UNITED STATES PATENT AND TRADEMARK OFFICE

APPLICATION NO.	FILING DATE	FIRST NAMED INVENTOR	ATTORNEY DOCKET NO.	CONFIRMATION NO.
10/537,082	01/20/2006	Denis Reibel	331.1095	8094

Office Action Summary

DETAILED ACTION

FIG. 1

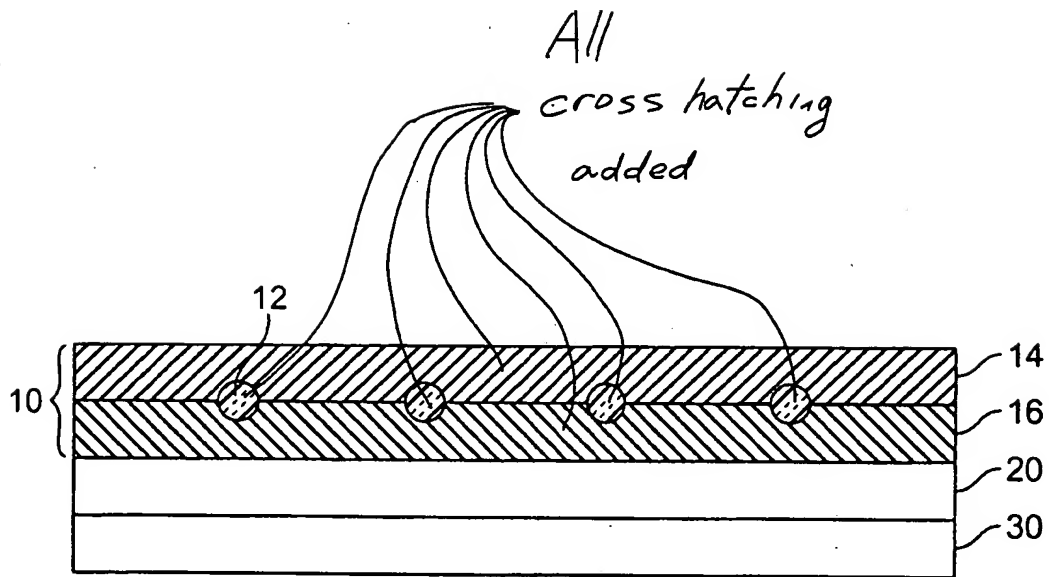
ANNOTATED SHEET

approved
1/16/07

- Line quality also generally improved
